NOTICE UNDER SECTION 96 OF ACT III OF 1901.

I beg to inform you that I intend building a mosqueon plot No. Mookam MarrodaSurvey Sheet No. K-28 situate in _____Street, Lycree Quarter.As required by the rules of the Municipality, I beg to submit herewith a 4 copies plan of the same for your approval.

PLAN OF PROPOSED MUSJID ON
MOOKAM MARRODA SHEET NR K-28
LYAREE Q8
SCALE 8"=1'

PLAN OF PROPOSED
MUSAFARKHANA AT MUKAM-
MAWASHAH ON PLOT N^o 2-K-28

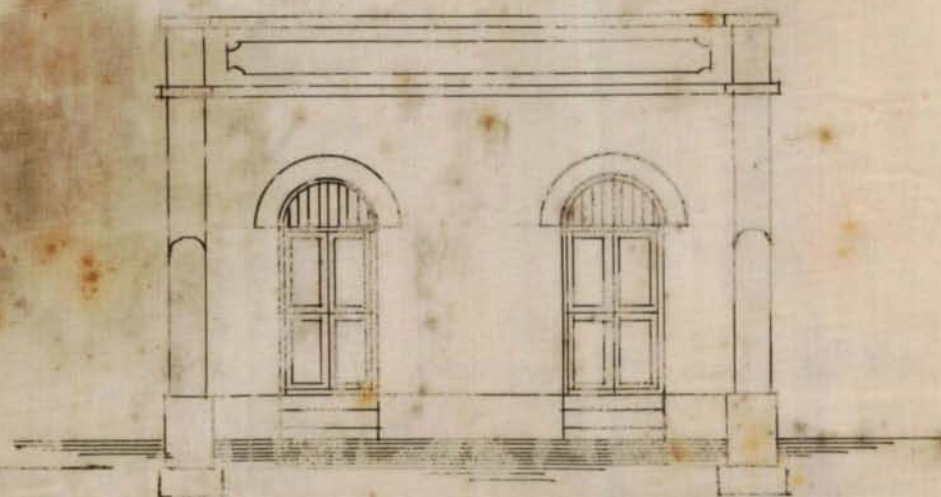
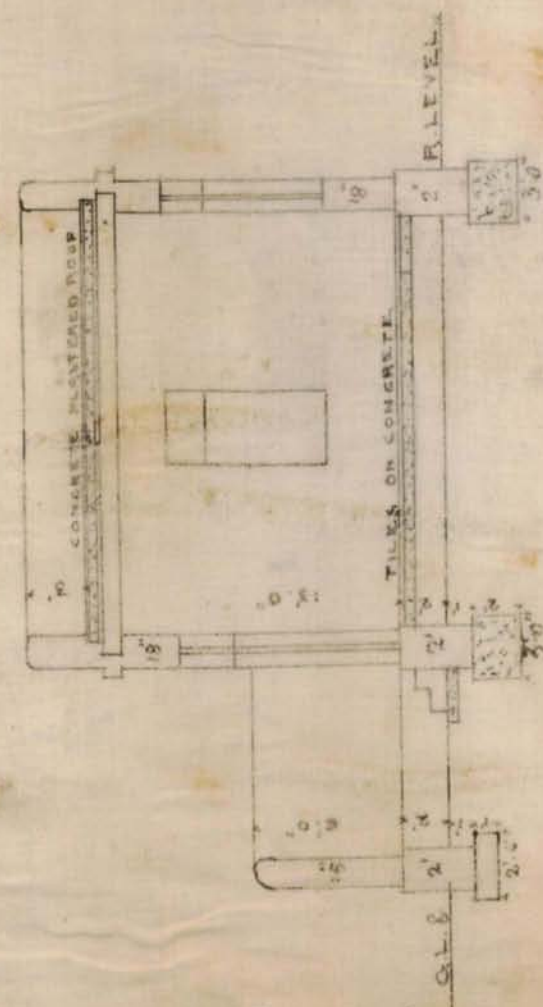
*The survey sheet given is incorrect.
The plot is in the 1/2 acre area and is
no objection.*

Remarks *Sir, I beg to report that there is no no
 given to the burial ground & boundary ground.
 But it is in the sheet of # 20. This is no sheet
 to allow to build a wall the corner of the
 CDC as at the burial ground. In his case*

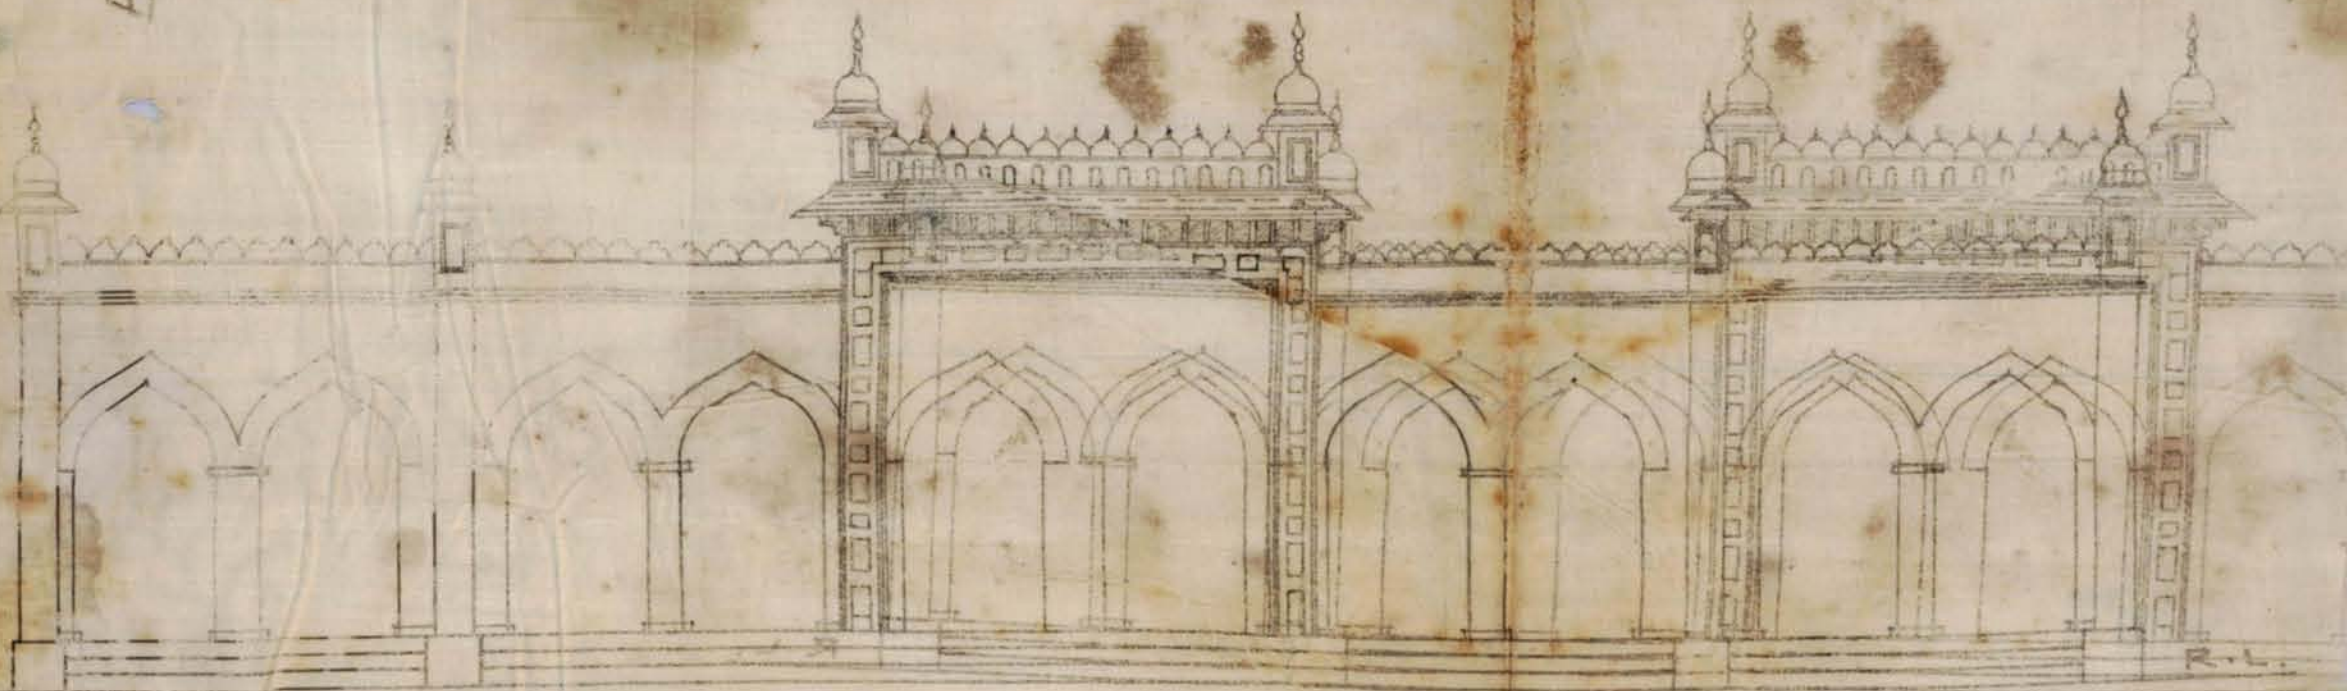
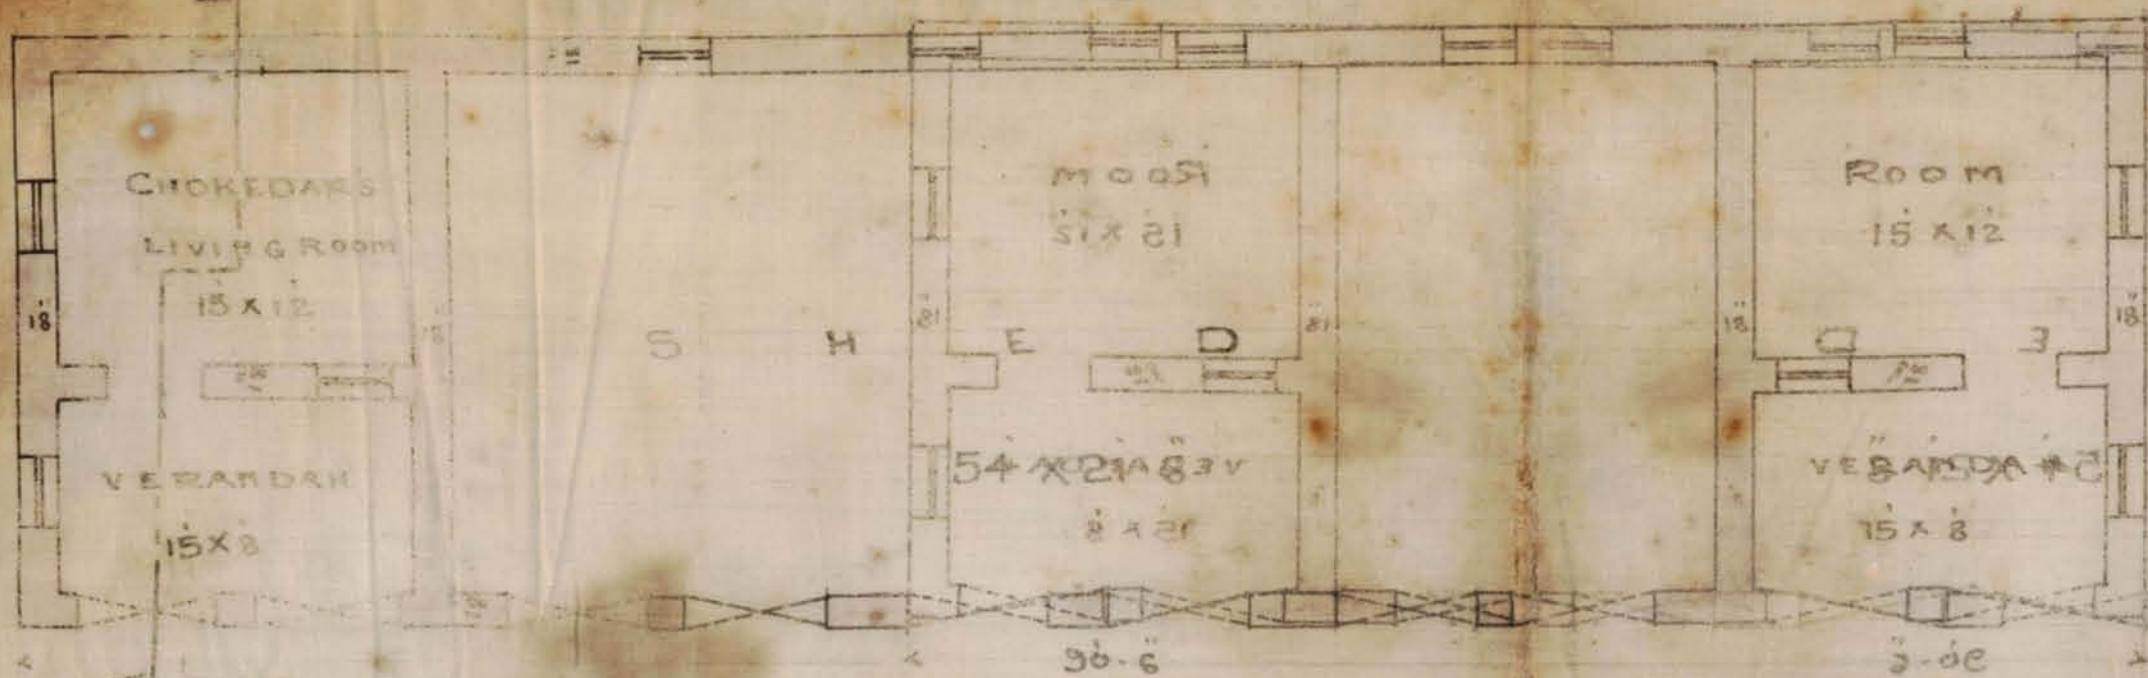
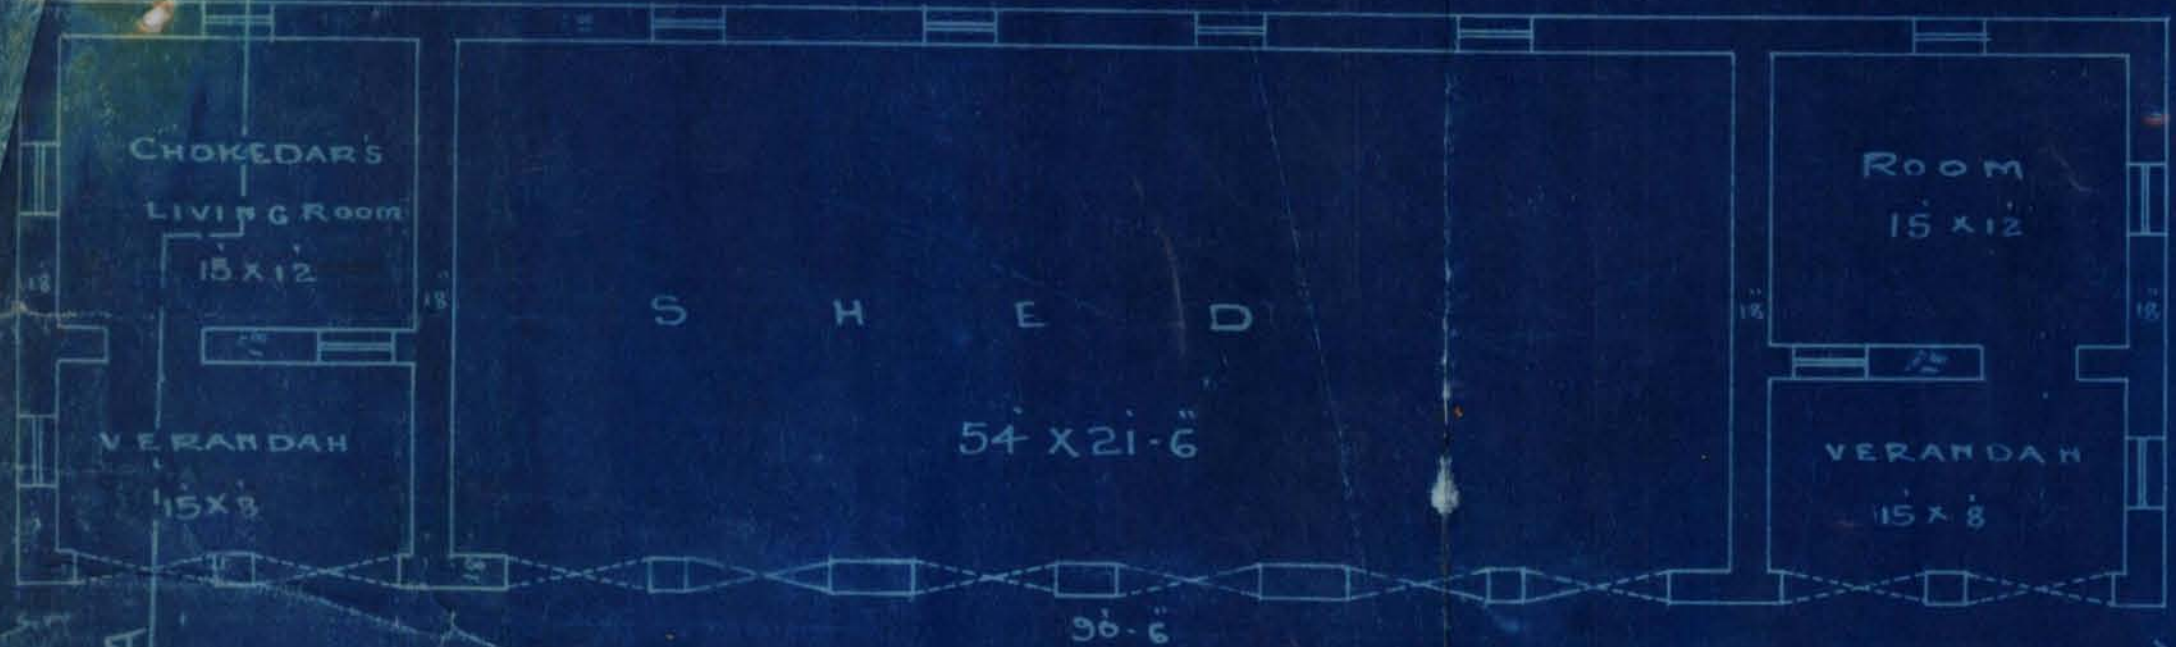
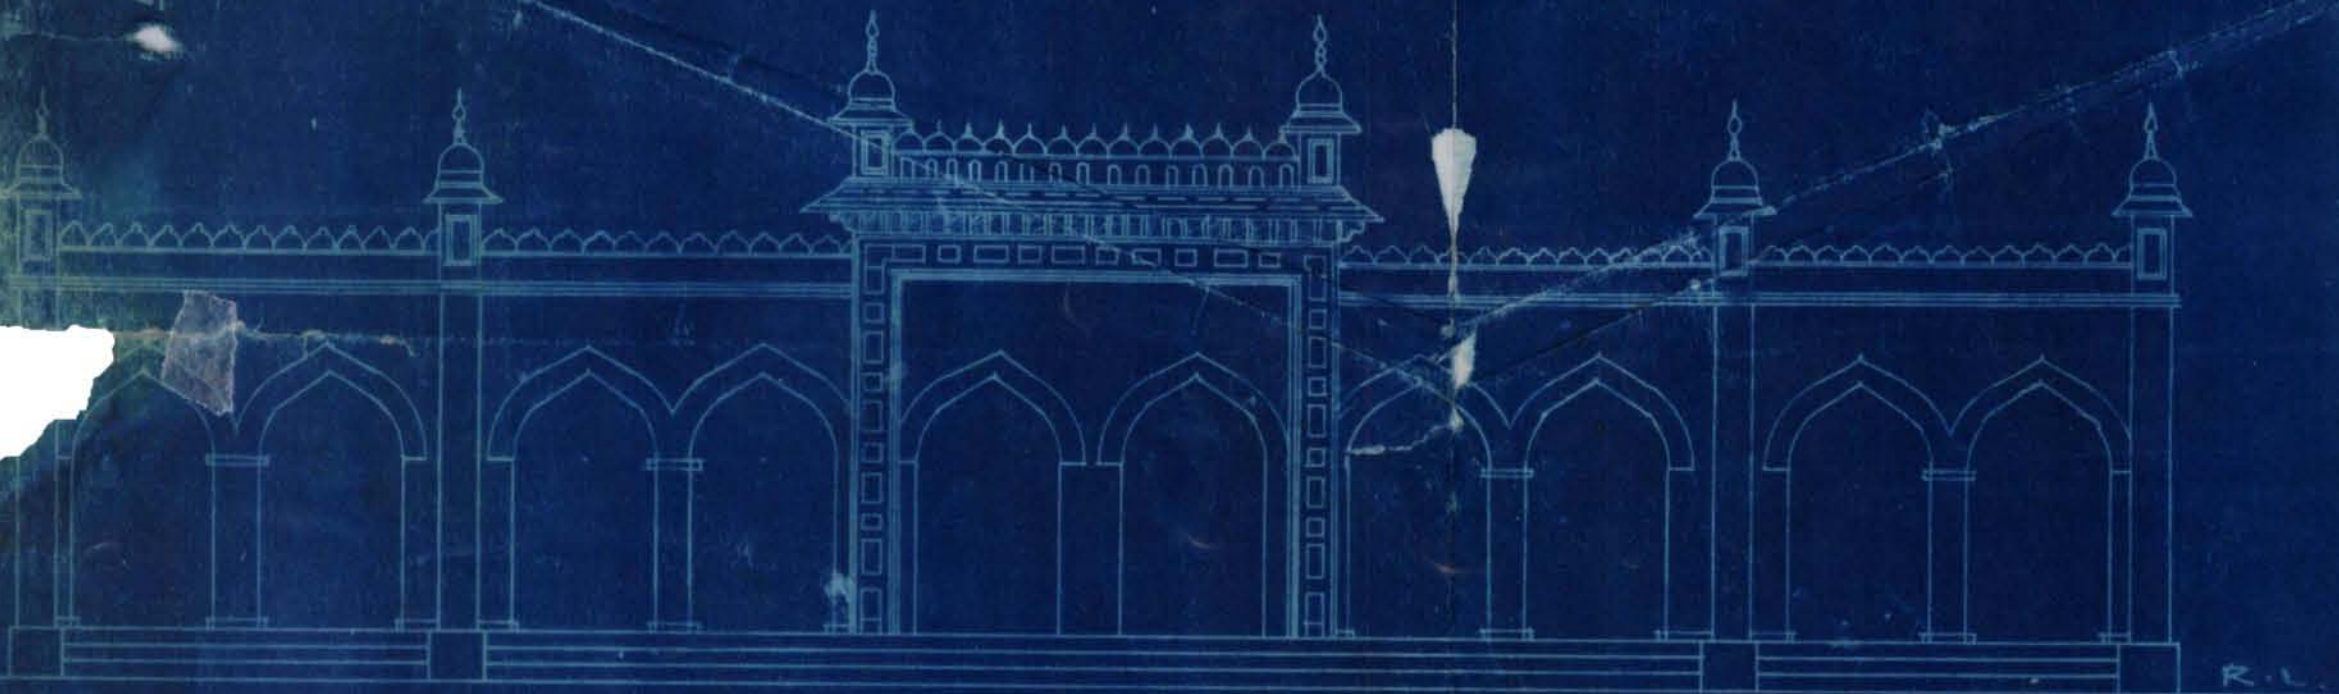
*The applicants must provide
paving & bath room*
